This Service Information bulletin supersedes SI B13 09 10 dated August 2010.
PERFORM THE PROCEDURE OUTLINED IN THIS SERVICE INFORMATION ON ALL AFFECTED VEHICLES THE NEXT TIME THEY ARE IN THE SHOP.

NEW Voluntary Emissions Recall Campaign 10E-A02: N54 High-Pressure Fuel Pump; Program Control Units

NEW E60, E61, E71, E82, E88, E90, E92, E93 with the N54 engine produced from 03/28/2006 to 02/26/2010

NEW LABEL INSTRUCTIONS

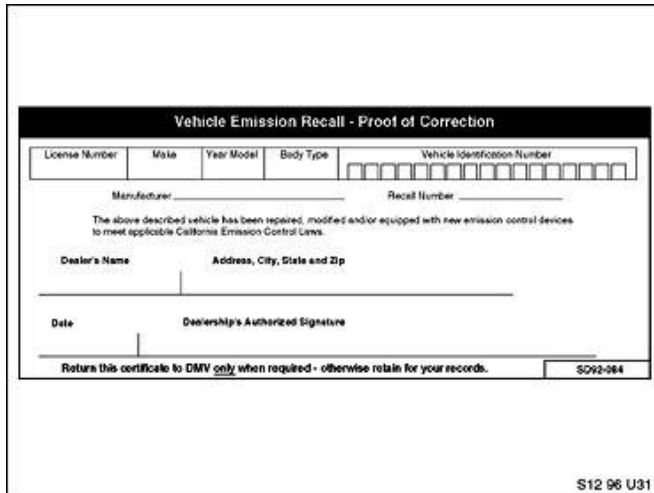
After the vehicle has been checked and corrected, obtain a label (SD 92-406) and with a ball point pen, print your dealer code (5 digits) on the Recall Completion Label (see illustration). An initial quantity of 200 labels will be sent to all BMW centers. Peel the label from its backing and affix it to the right (passenger) rear side of the hood in the engine compartment, close to windshield.

For California centers only: It is required by the California Code of Regulations that an executed orange "Vehicle Emission Recall - Proof of Correction" certificate (SD92-084, see illustration) be provided to each customer (for vehicles registered in the state of California), once the Recall on his or her vehicle has been completed.
